Application Number P25-02

Lafayette Road Convenience Store/Gas Station/Drive Through

Property Owner: Leonard and Sandra Shelter
Applicant: Stephen Berry
Location: 999 Lafayette Road
Zoning: C-3 (General Commercial)
Request: Site Plan and Conditional Zoning Certificate approval for a convenience store, motor vehicle filling station, and drive through

1 SITE PLAN
SCALE: 1" = 30'

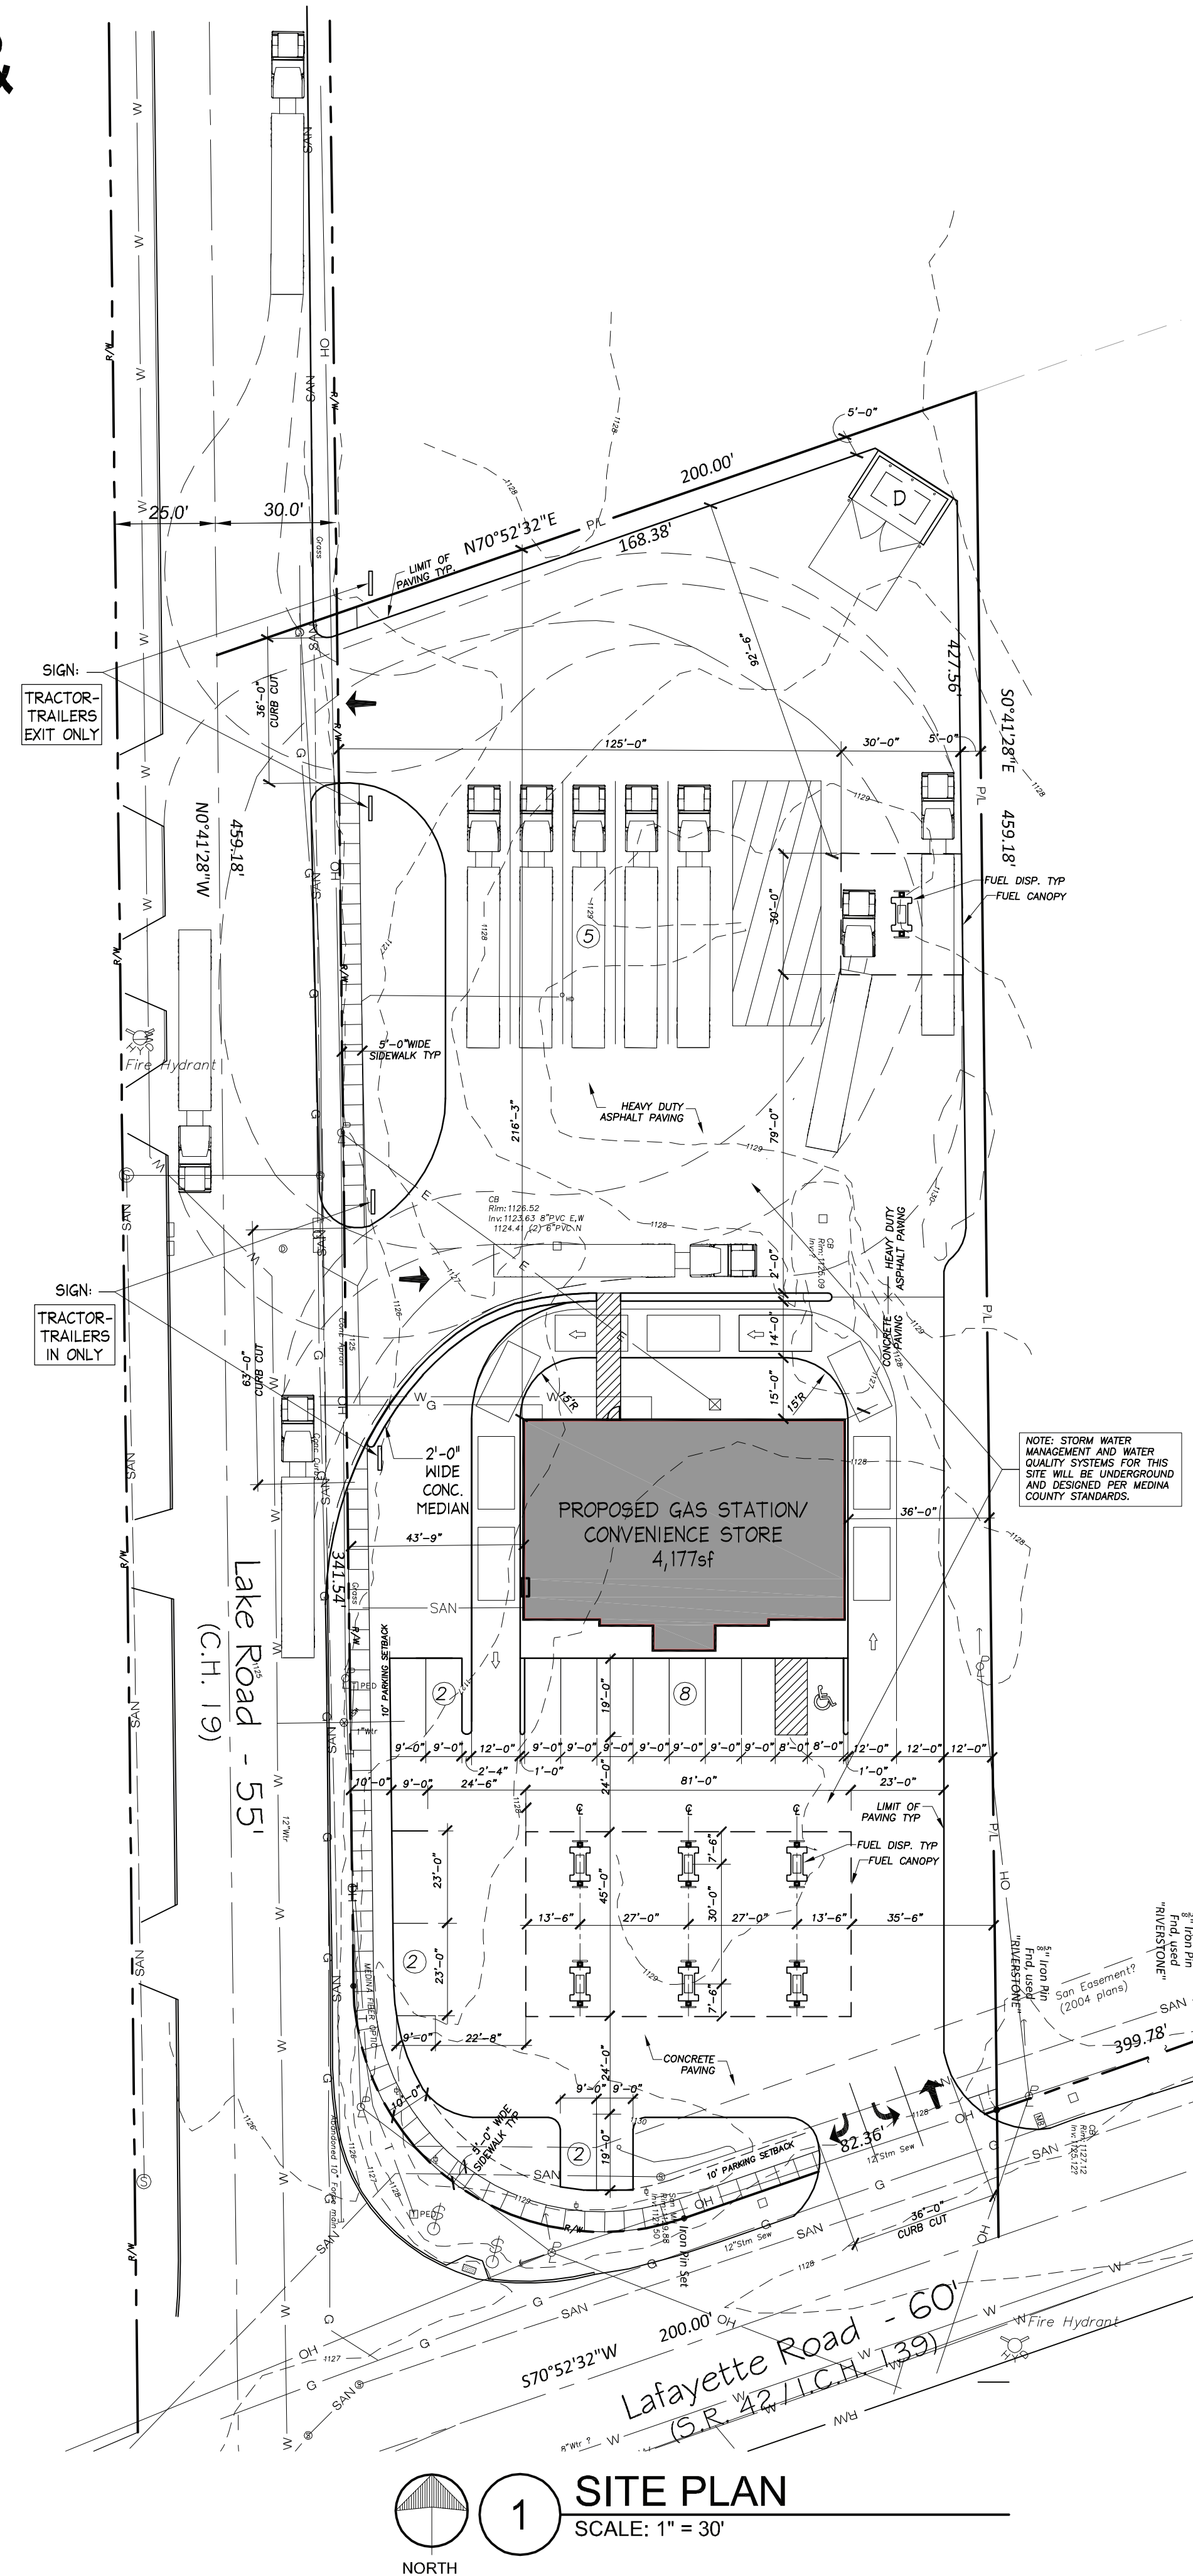
Sidewalk – A public sidewalk is shown on Lake Road and Lafayette Road, as required. The sidewalk will need to be configured to access the existing crosswalk ramp at the corner. In addition, Section 1130.10 requires a sidewalk connection from the public sidewalk to the convenience store building.

Though parking is located 10 ft. from the right-of-way, the landscape strip is 5 ft. in width to the south and west of the passenger vehicle fueling area, which requires Planning Commission approval.

Parking Lot Landscaping – Landscape features or other visual barriers are required between parking and the right-of-way. Plans show landscaping between parking and the right-of-way. As there are no trees located to the south of the building, two trees could be located in the area marked “LAWN” adjacent to Lafayette Road.

- (1) The project shall comply with Sections 1145.10(e) and 1153.04(d)(15)(B.) regarding the number and width of access points or receive variance approval from the Board of Zoning Appeals.
- (2) The proposed public sidewalk shall connect with the existing curb ramp at the corner of Lafayette Road and Lake Road and a private sidewalk shall connect from the public sidewalk to the convenience store building per Section 1130.10.
- (3) Two trees shall be located adjacent to Lafayette Road in the area marked "LAWN" on the Landscaping Plan.
- (4) A light fixture detail shall be submitted in compliance with Section 1145.09(c)(6).

1 PHOTOMETRIC STUDY
SCALE: 1" = 30'

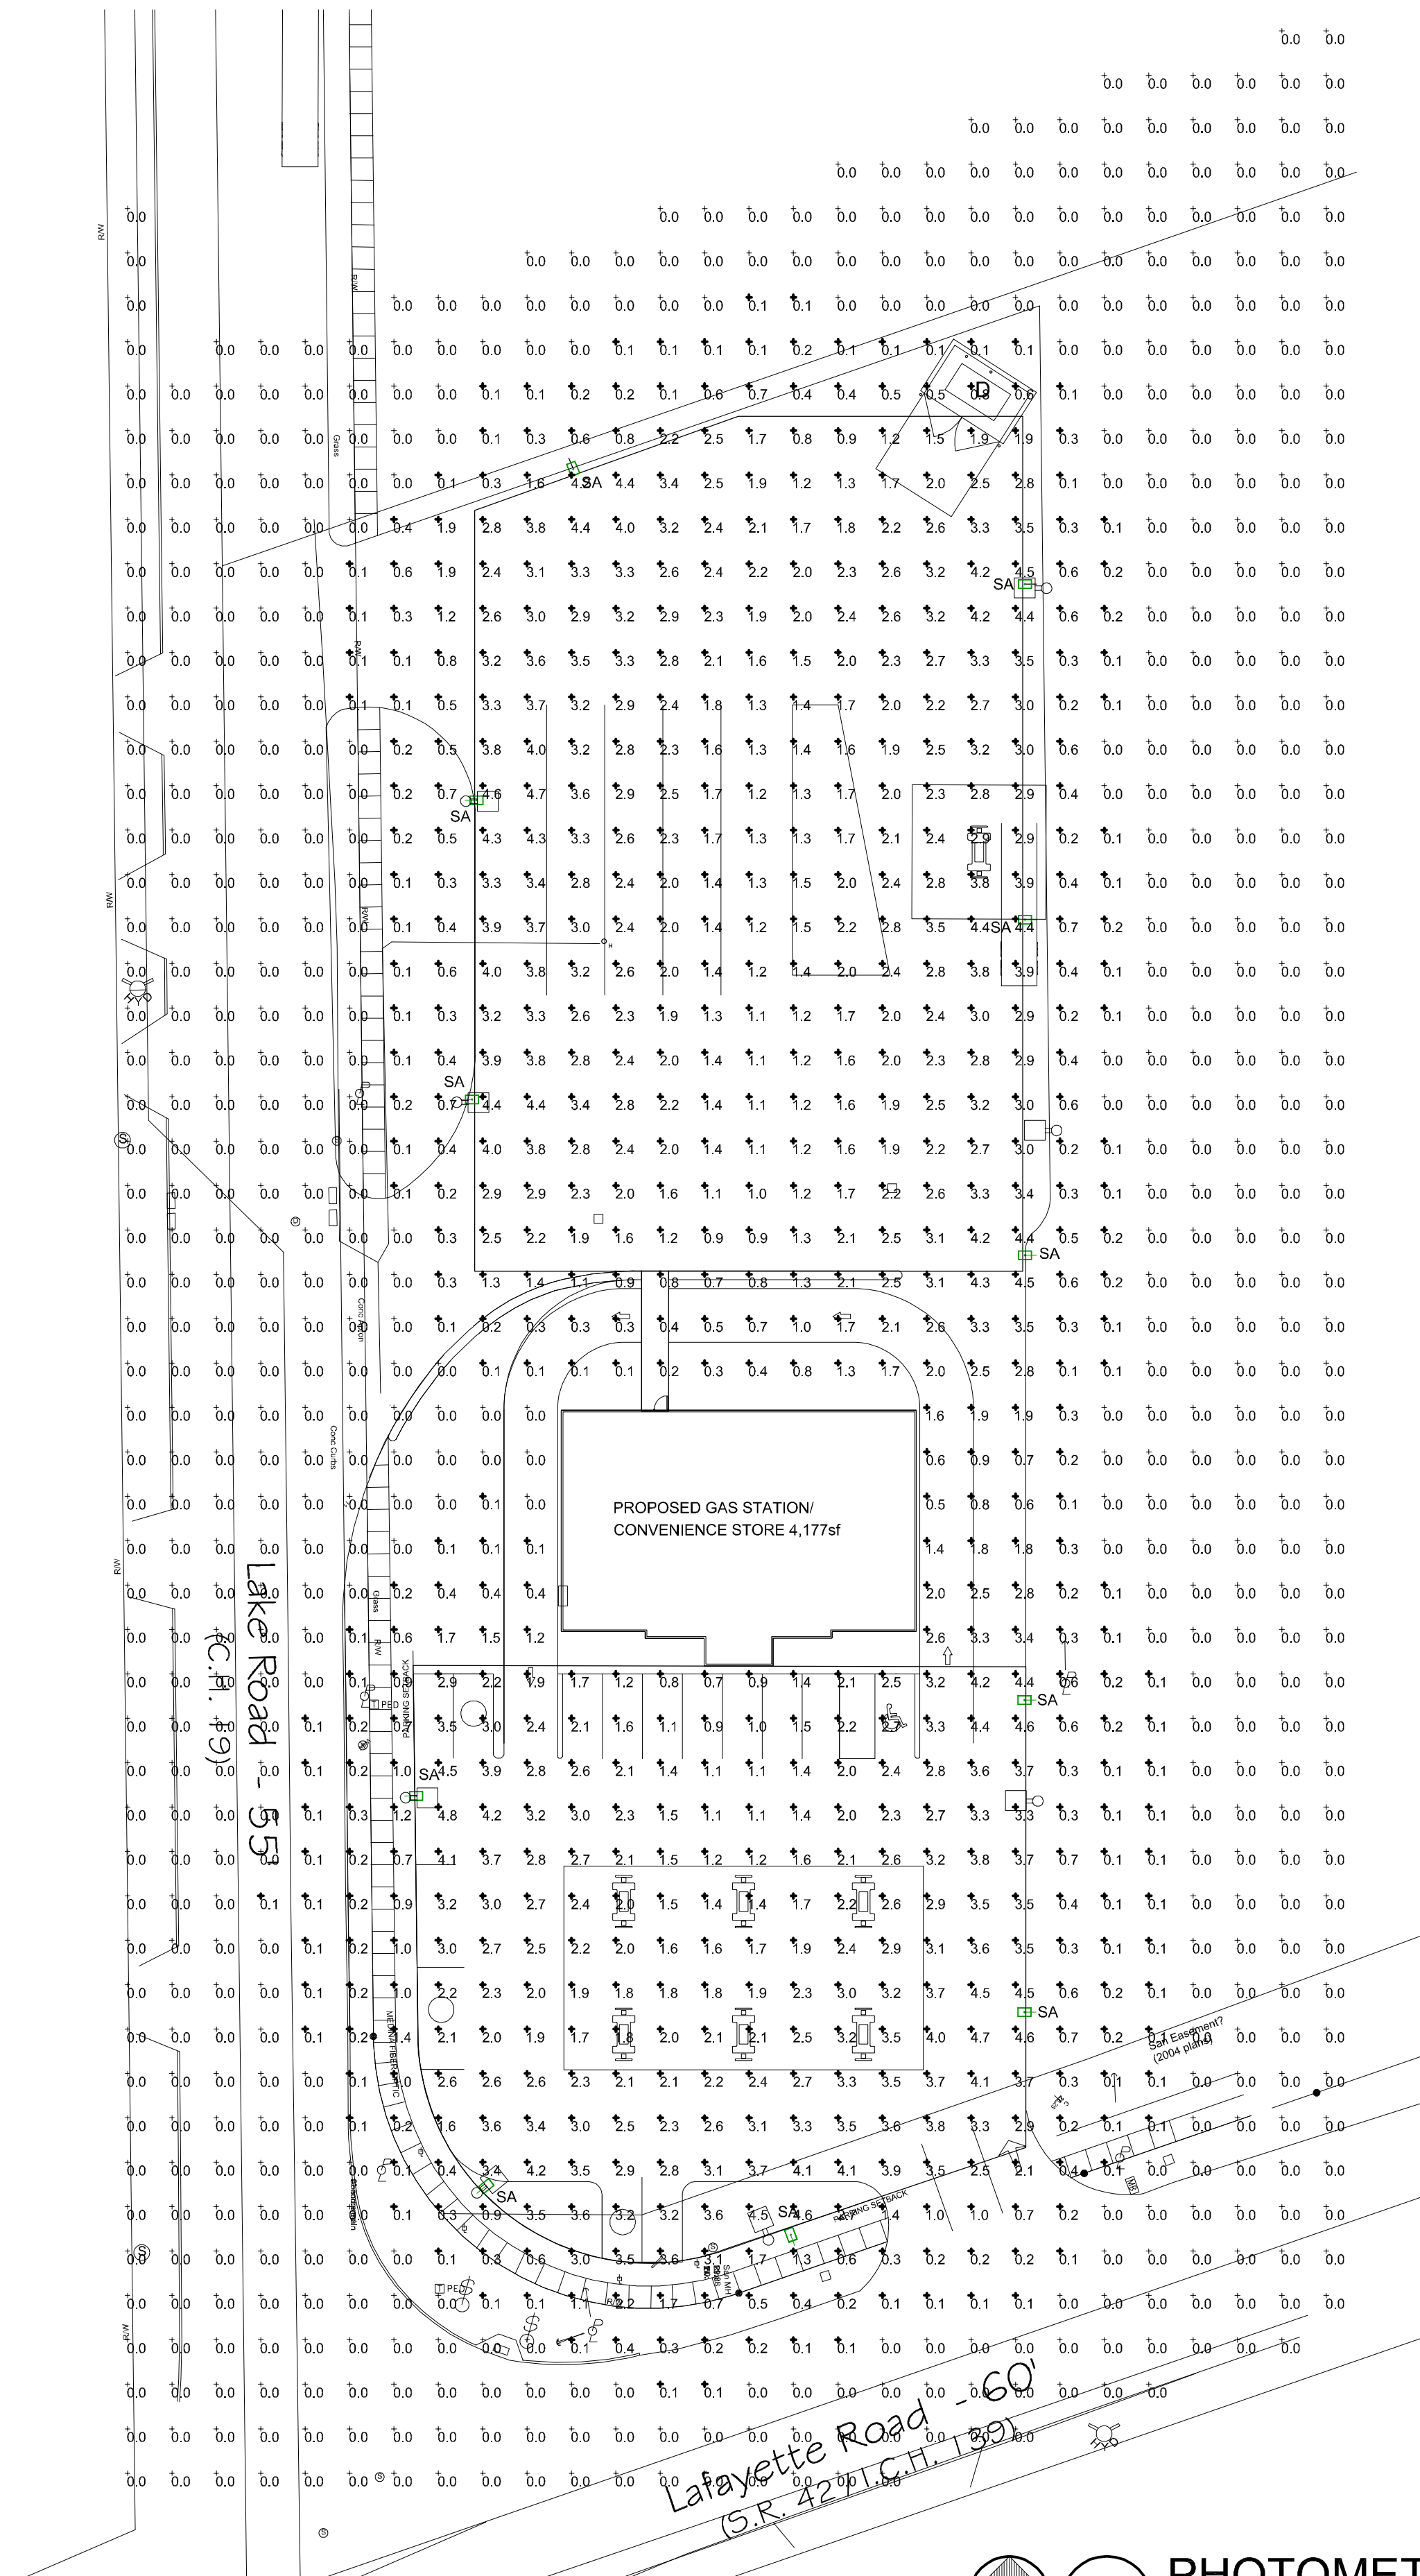
A lighting plan has been submitted with a compliant photometric plan and a maximum lighting height of 22 ft. Light fixtures appear to be full cut-off, as required, though the applicant will need to verify the fixture type.
